# UNITED STATES PATENT AND TRADEMARK OFFICE

APPLICATION NO.	FILING DATE	FIRST NAMED INVENTOR	ATTORNEY DOCKET NO.	CONFIRMATION NO.
09/729,443	12/04/2000	Steven T. Jaffe	36928/NJP/B600	6265
23363	7590	06/15/2005	EXAMINER	
CHRISTIE, PARKER & HALE, LLP			TORRES, JUAN A	
PO BOX 7068			ART UNIT	
PASADENA, CA 91109-7068			PAPER NUMBER	
			2631

## Office Action Summary

## **DETAILED ACTION**

Figure #1  
Prior Art

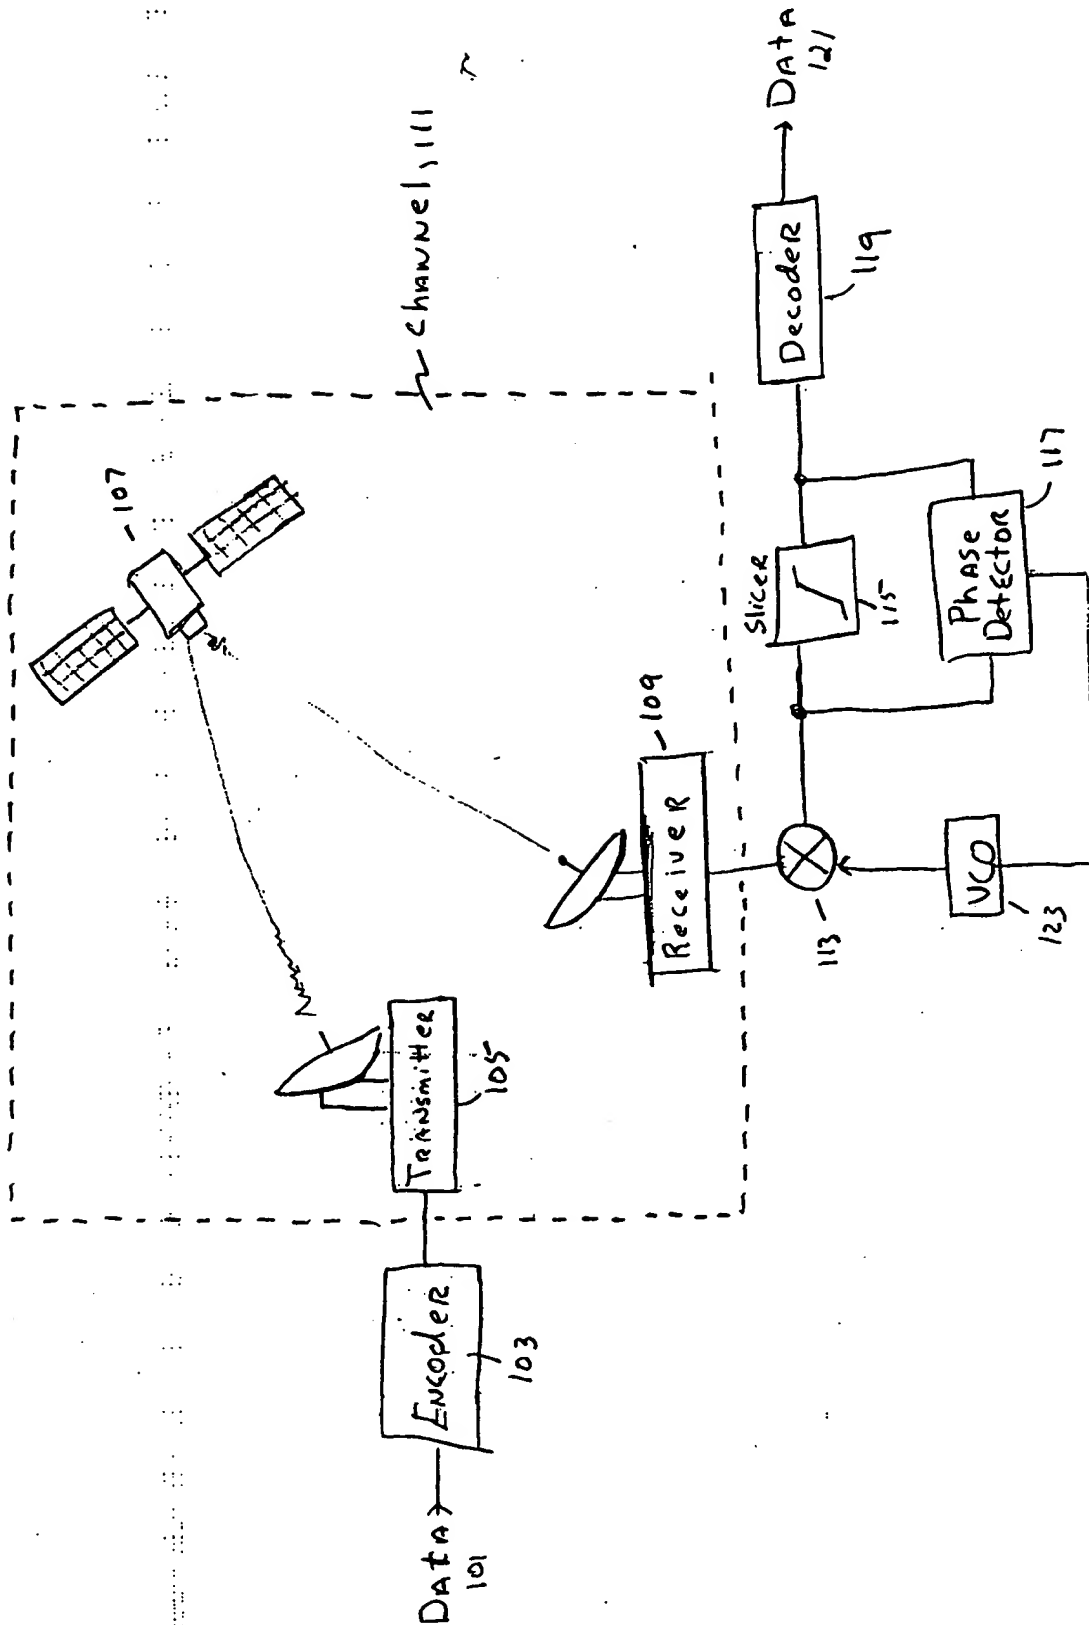
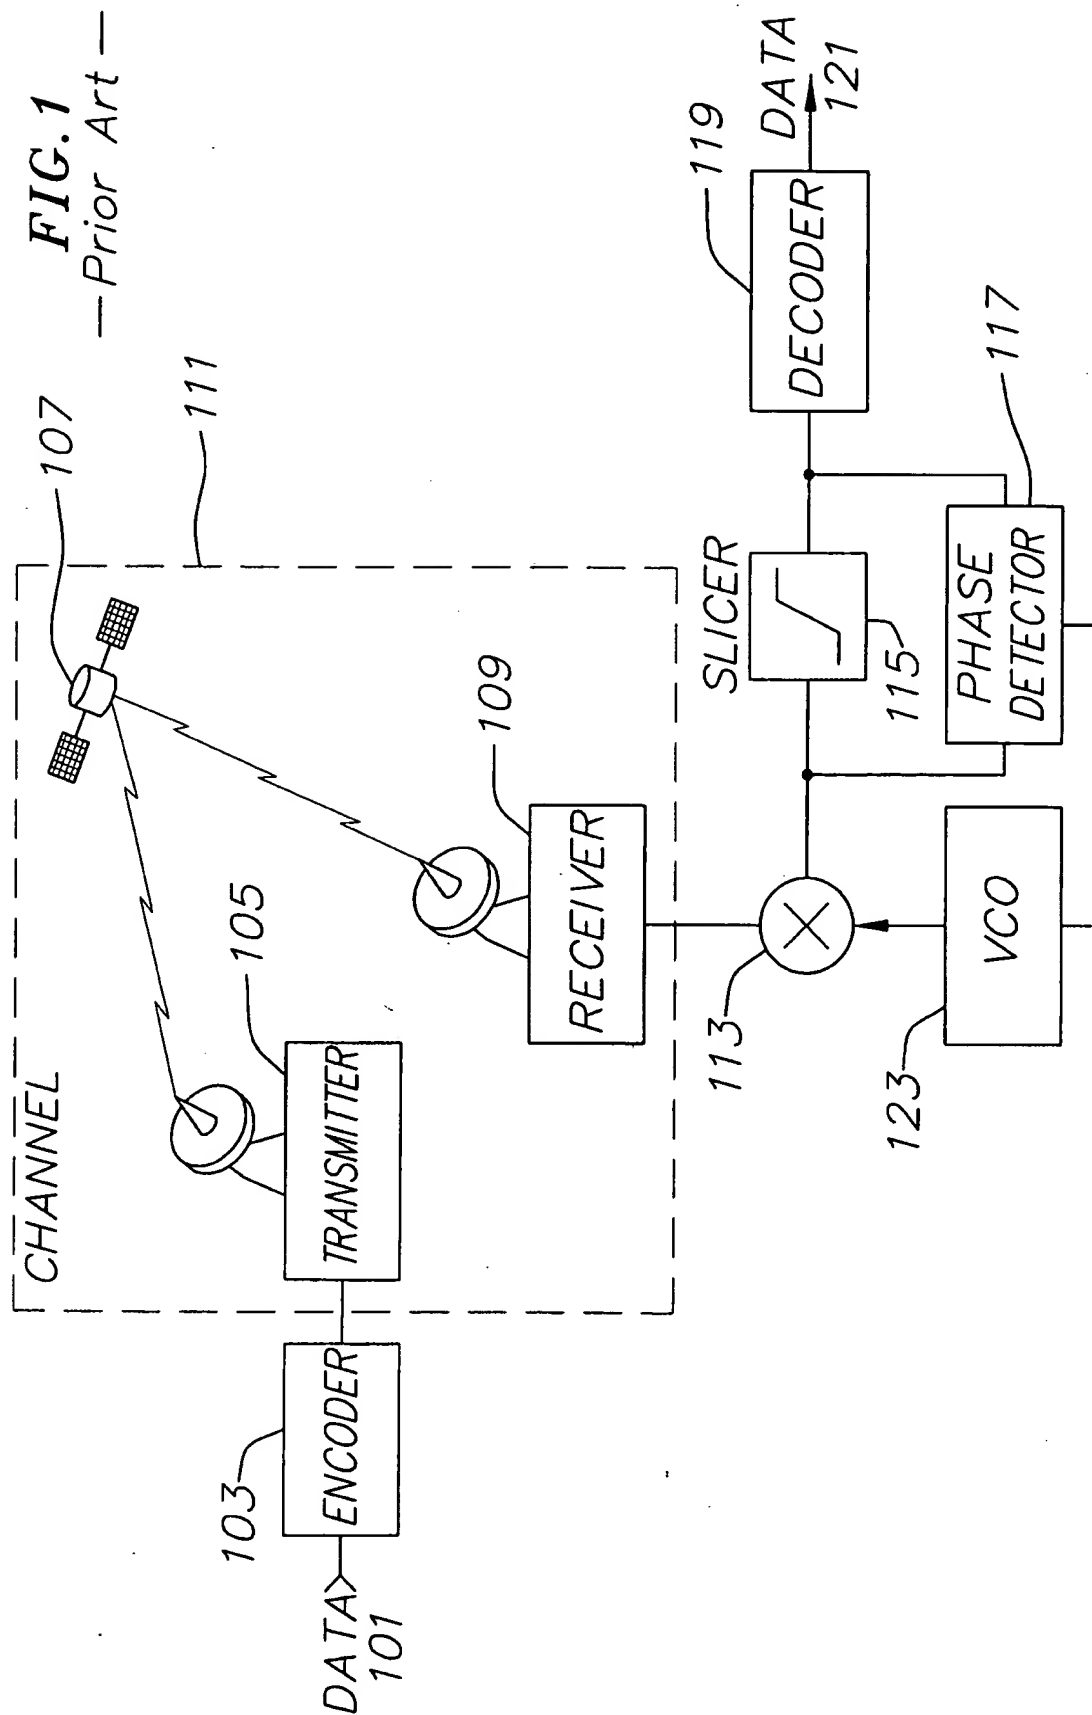
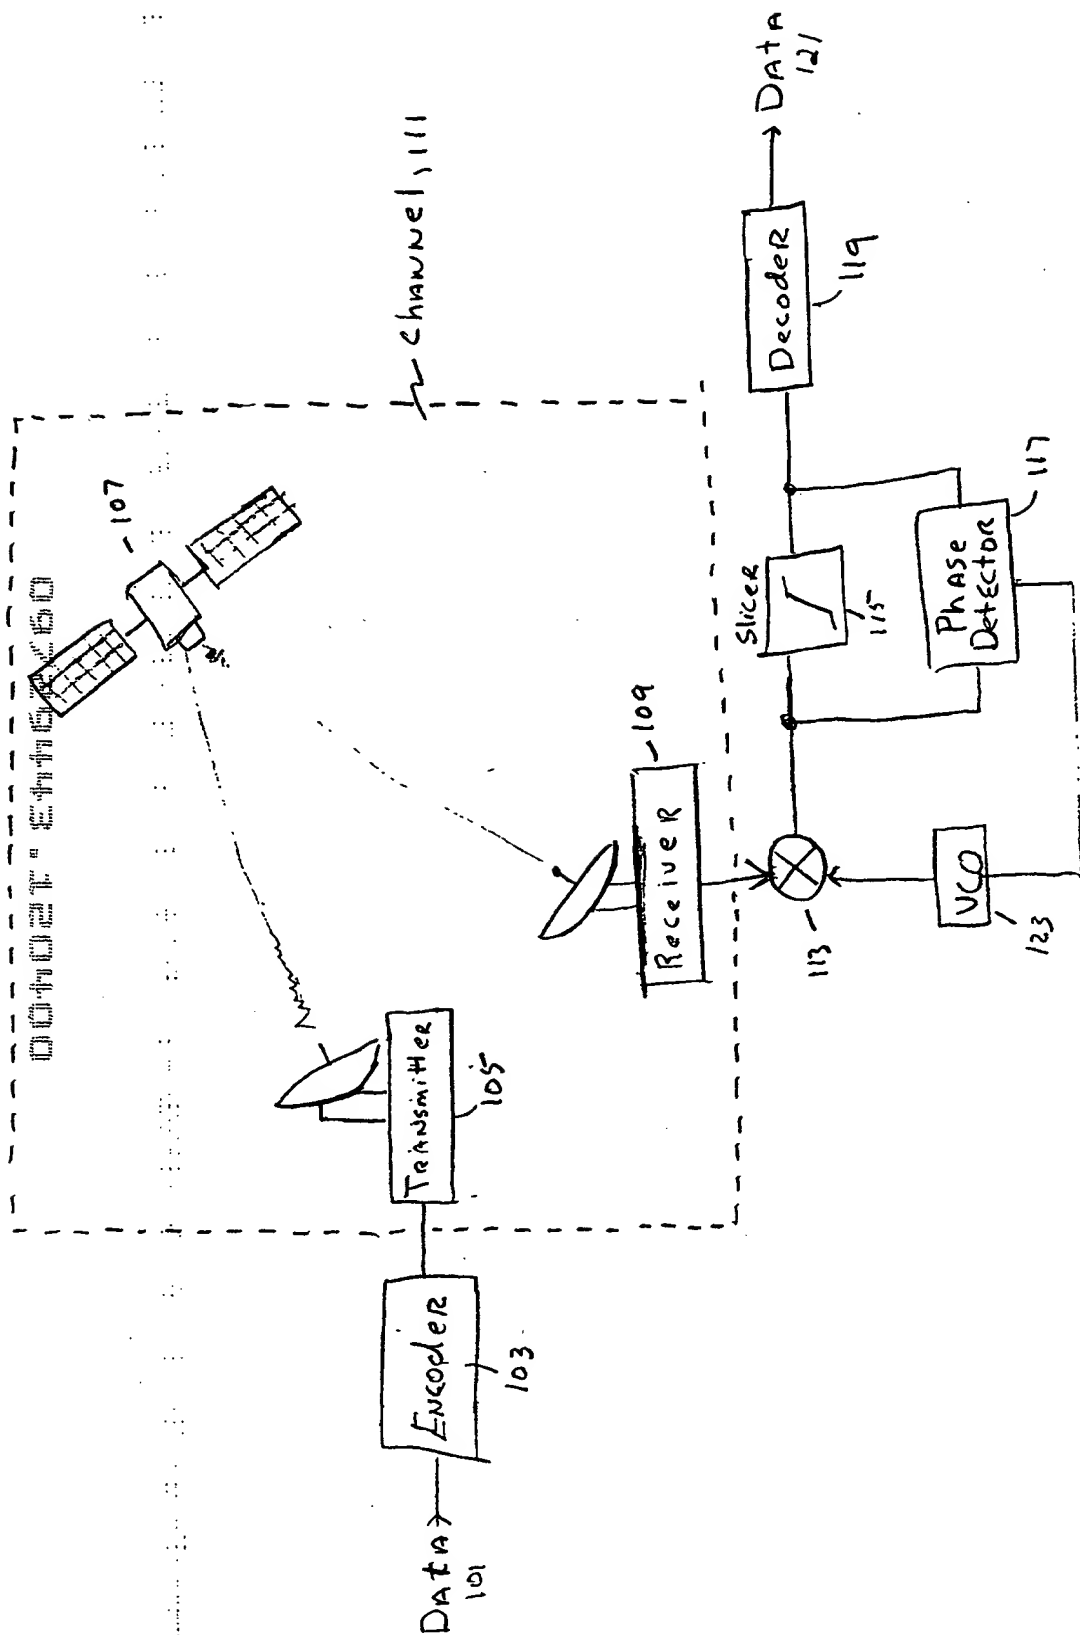
The attached sheets of drawings include changes to Figs. 1 and 2. These sheets, which include Figs. 1 and 2, replace the original sheets including these figures.
